**SUBJECT: THREE MILE ISLAND NUCLEAR STATION, UNIT 1 – STAFF ASSESSMENT  
OF RESPONSE TO 10 CFR 50.54(f) INFORMATION REQUEST – FLOOD-  
CAUSING MECHANISM RE-EVALUATION (CAC NO. MF1113)**

STAFF ASSESSMENT BY THE OFFICE OF NUCLEAR REACTOR REGULATION

RELATED TO FLOODING HAZARD REEVALUATION REPORT

THREE MILE ISLAND NUCLEAR STATION, UNIT 1

Figure 3.4.1-1 – Upstream Modeled and Grouped Dams (FHRR Figure 26)

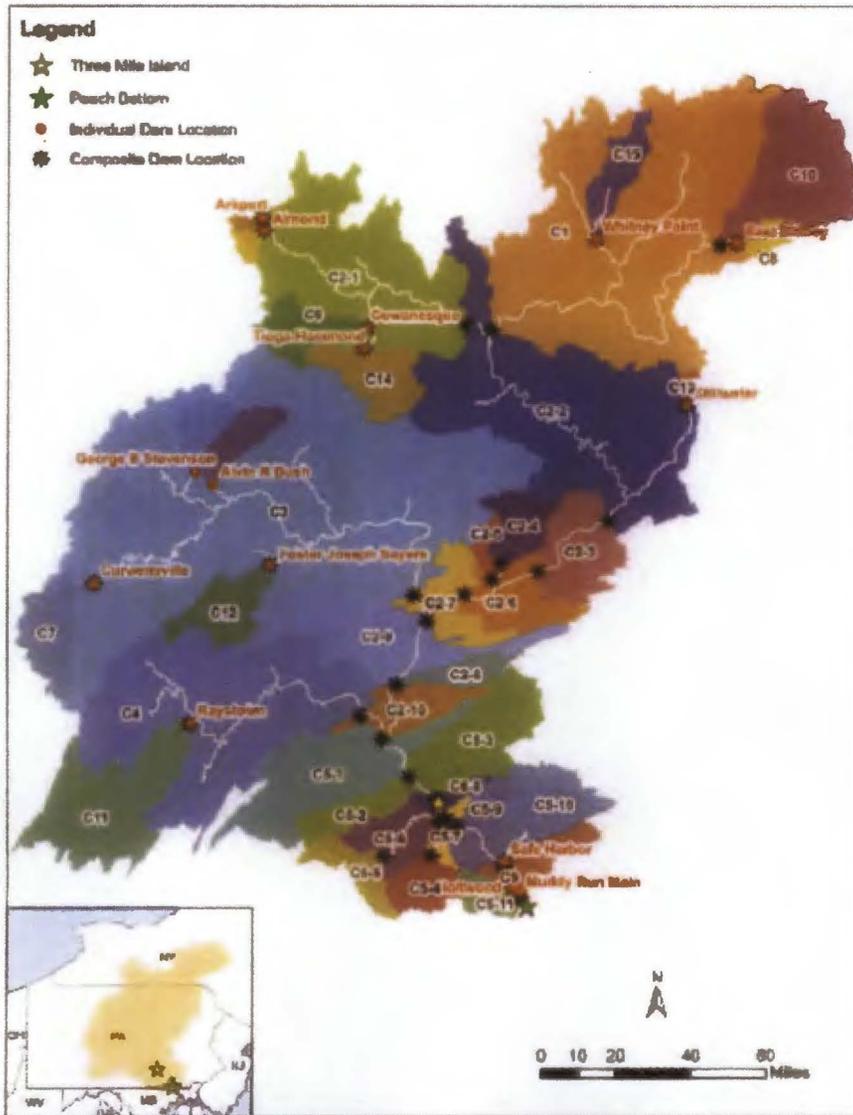
The licensee reported that the USACE National Inventory of Dams Database (NID) shows 708 dams in the Susquehanna River watershed upstream of TMI. Of the 708 dams, 279 were identified as inconsequential and screened from further evaluation using JLD-ISG-2013-01 (NRC, 2013b). Ultimately, the licensee individually modeled 15 dams and grouped the remaining dams into 34 "hypothetical" dams. Figure 3.4.1-1 shows the modeled dams. The licensee used methodologies presented by Froehlich (2008) and Xu and Zhang (2009) to develop breach parameters for the dams for use in HEC-HMS.
